# Information for IPAA-EPA Meeting
## Subpart OOOOa
March 13, 2018

Manipulating Data to Create the Illusion That Low Producing Wells Are "Super-Emitters"

This document addresses data manipulation issues in the environmentalist study submitted to the rulemaking proposal for Subpart OOOOa to distort the role of low producing wells regarding methane emissions. This study was then characterized as the basis for removing the low producing well exclusion for the Subpart OOOOa fugitive emissions program initially proposed by the Environmental Protection Agency (EPA).

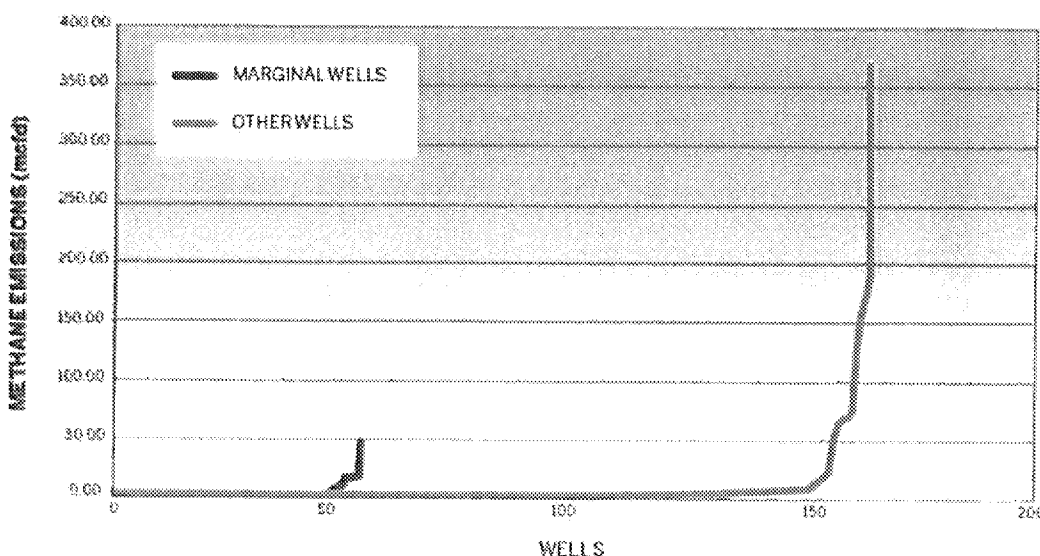
Before turning further to describe the submitted study, it is useful to look at the same data using a direct graph of emissions. In this graph, marginal wells are those with production volumes of 90 mcfd or less.

This graph is consistent with information from other studies showing that a small portion of wells have an emission profile for some reason with high emissions and most wells have really low emissions. Importantly, it also clearly shows that marginal wells – low producing wells in the context of the regulation – have far smaller emissions. But, since this graph is using the same data as the study, it could also be overstating emissions because of scaling short term emissions to a daily amount.

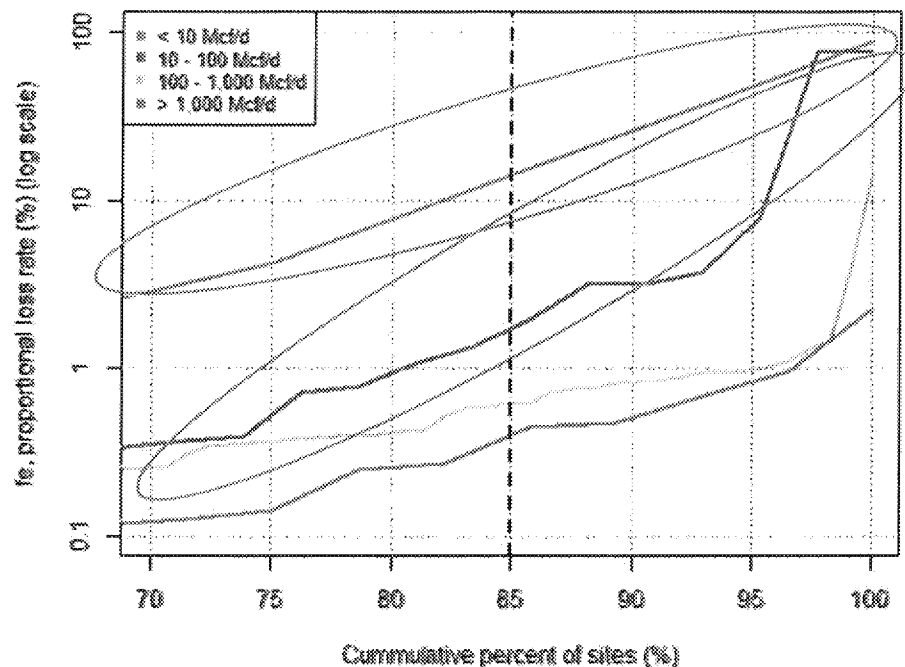
Below is the graphic used to present the data. It would suggest that the worst emitting operations – the "super-emitters" – are the smallest wells (the orange line and the blue line, circled in green). Having directly plotted this data, the obvious issue is how such a result can occur.

It is a busy and confusing graph – it's intended to be. The study uses data analysis tricks to create the appearance that marginal wells are "super-emitters".

First, it shows emissions as a percentage of production rather than actual emissions. Thus, one mcf emitted out of ten mcf produced is 10 percent, but 50 mcf emitted out of 1000 mcf produced is 5 percent. As a result, it skews the perception of the data to imply that low producing wells are large emitters when they are not.

Second, its production volumes are really sales volumes, not the amount extracted from the wellhead. Consequently, a "proportional loss rate" of 50 percent would be the calculated loss divided by the volume sold. If the percentage of loss were calculated based on extracted volumes, the 50 percent "proportional loss rate" would drop to 33 percent because the loss would be added to the sales volume to obtain the extracted volume.

Third, it only shows data from the 70[th] percentile of information. This excludes all of the virtually zero emissions that dominate the data.

Fourth, it uses a logarithmic scale to present the data. One of the reasons to use logarithmic scales is to flatten curves to make them look more like straight lines.
